# CITY OF ALBUQUERQUE

**Re: Kairos Power Expansion**  
**5201 Hawking Dr. SE**  
**Traffic Circulation Layout**  
Architect's Stamp XX-XX-XX (Q16-DA5000A)

## TRAFFIC CIRCULATION PLAN

## ENLARGED TRAFFIC CIRCULATION LAYOUT

A-111

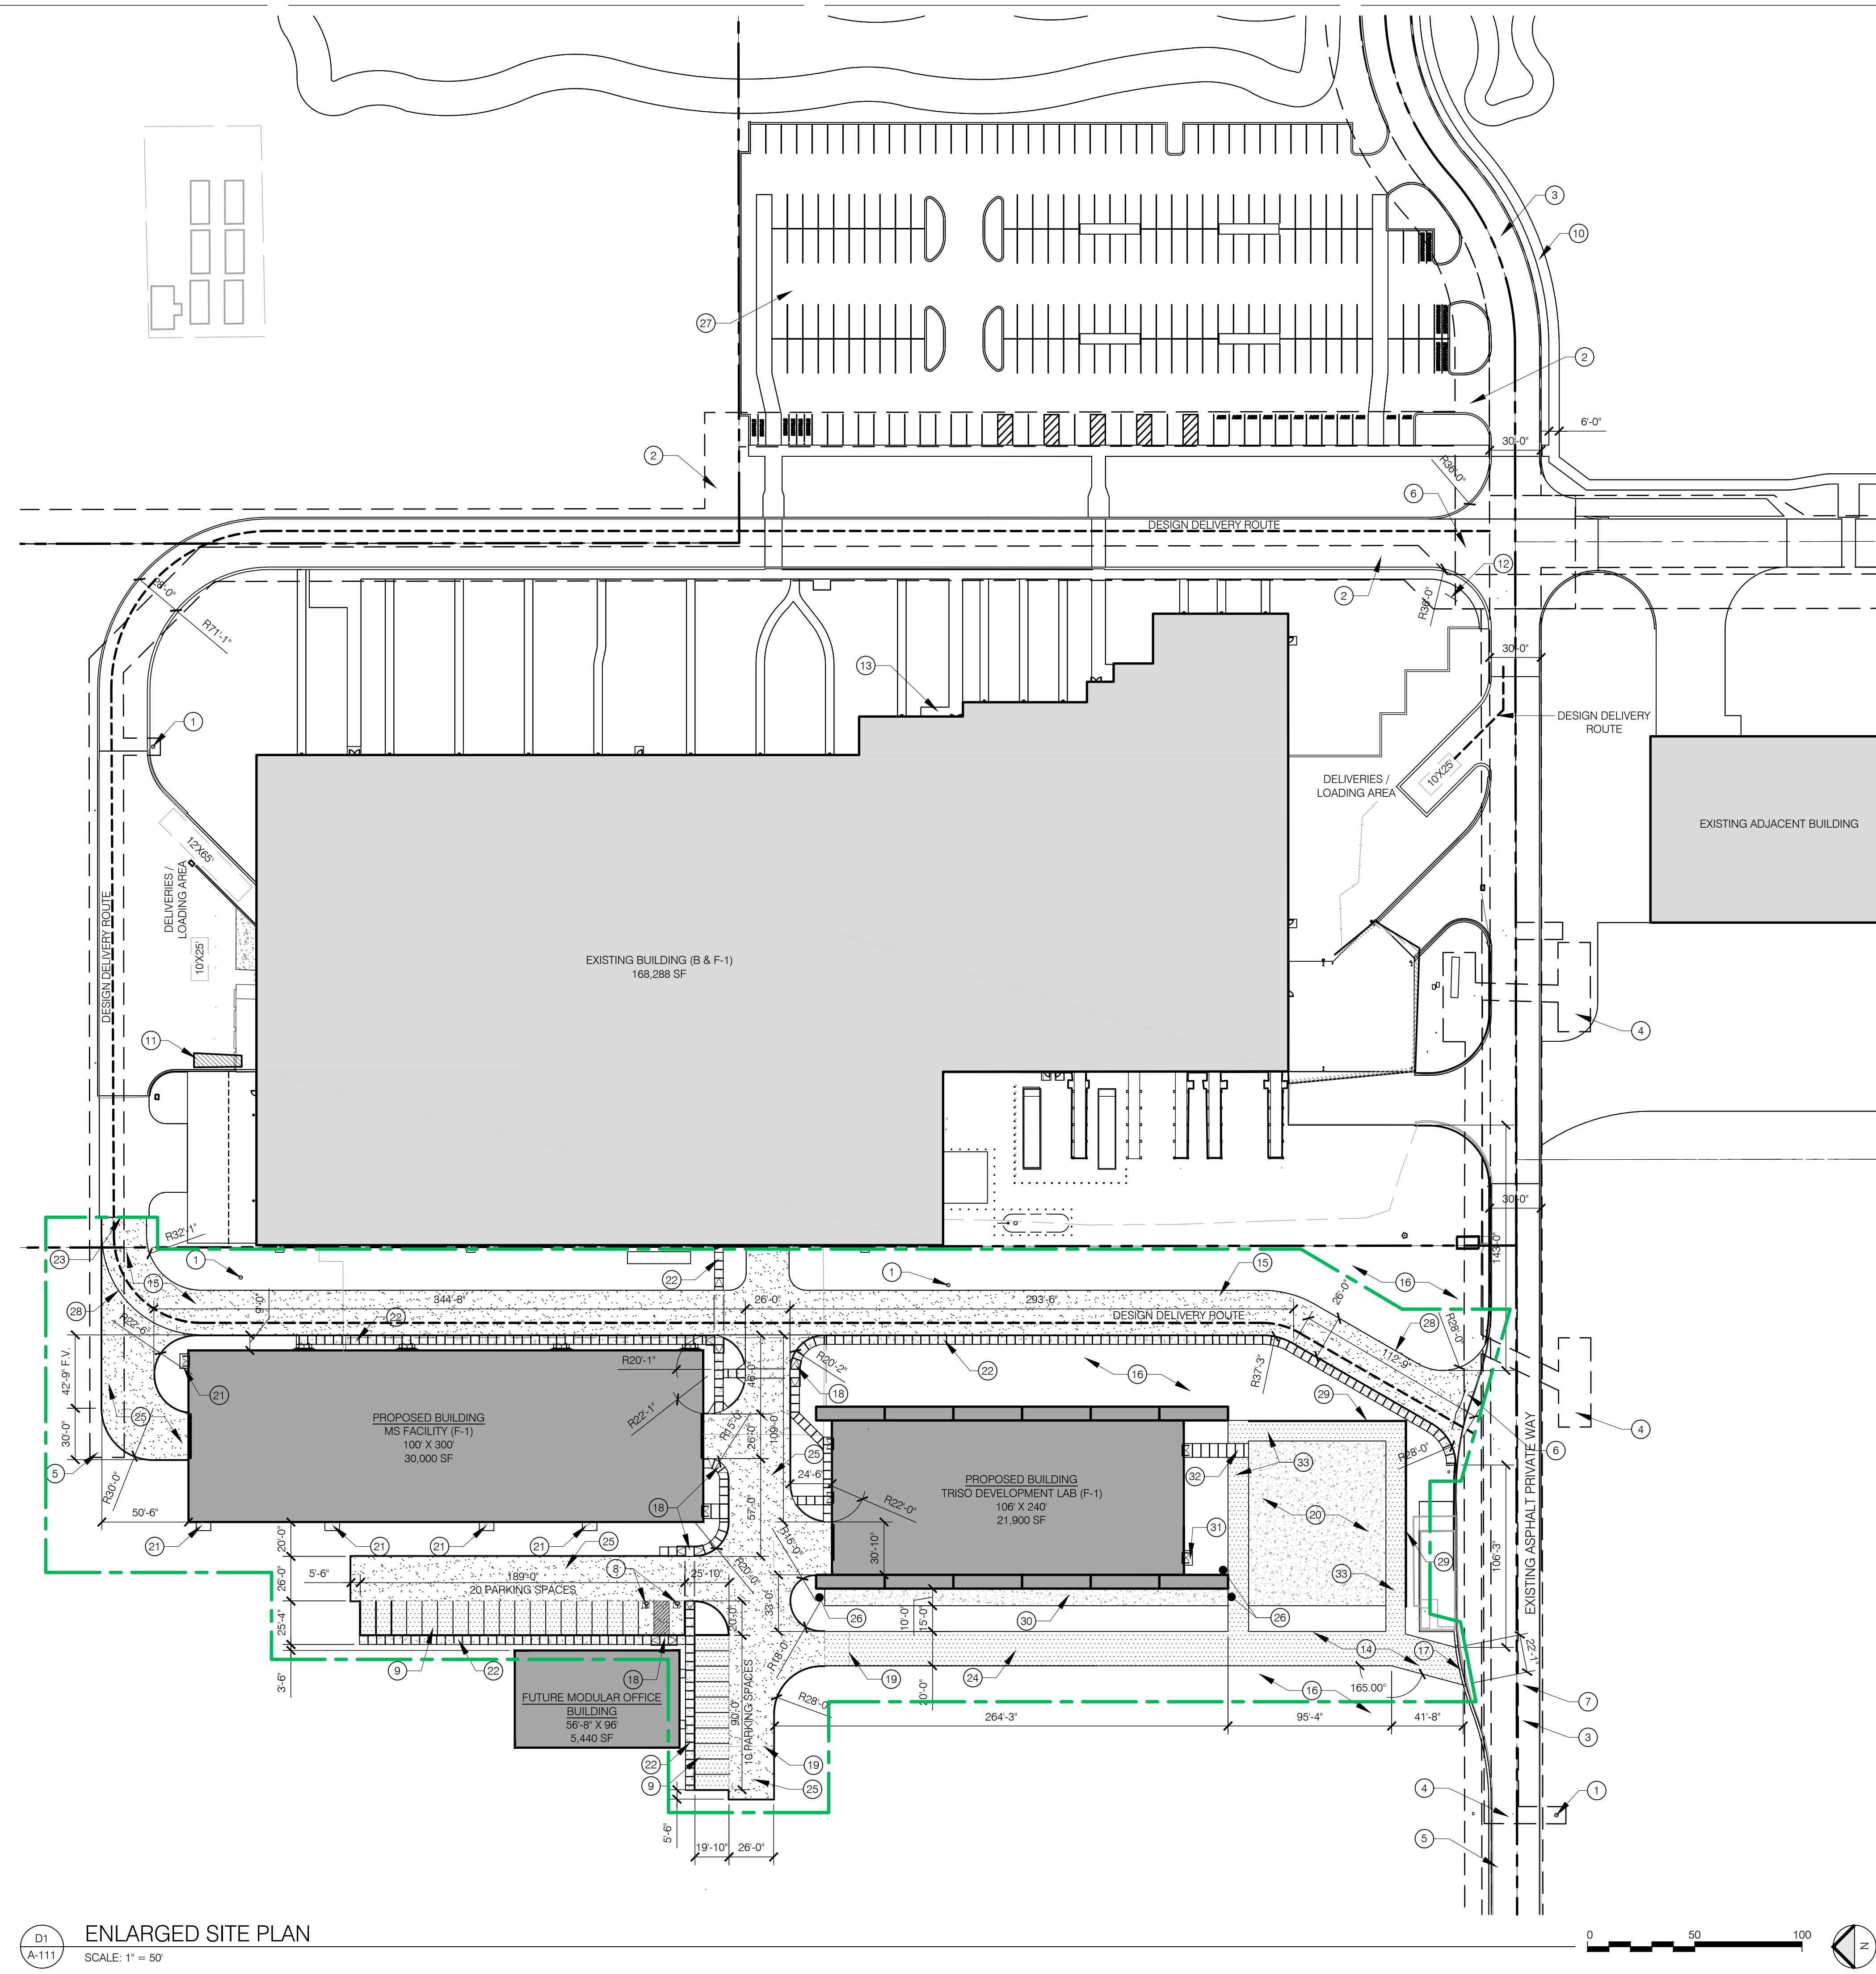
7. ADA curb ramps must be updated to current standards and have truncated domes installed.
8. Keynote 18: provide all proposed ramps details and reference COA std dwg.

9. Keynote 22: please reference COA std dwg 2430 for the proposed sidewalk.
10. Keynote 17: is this will be one way or two-way drive aisle?
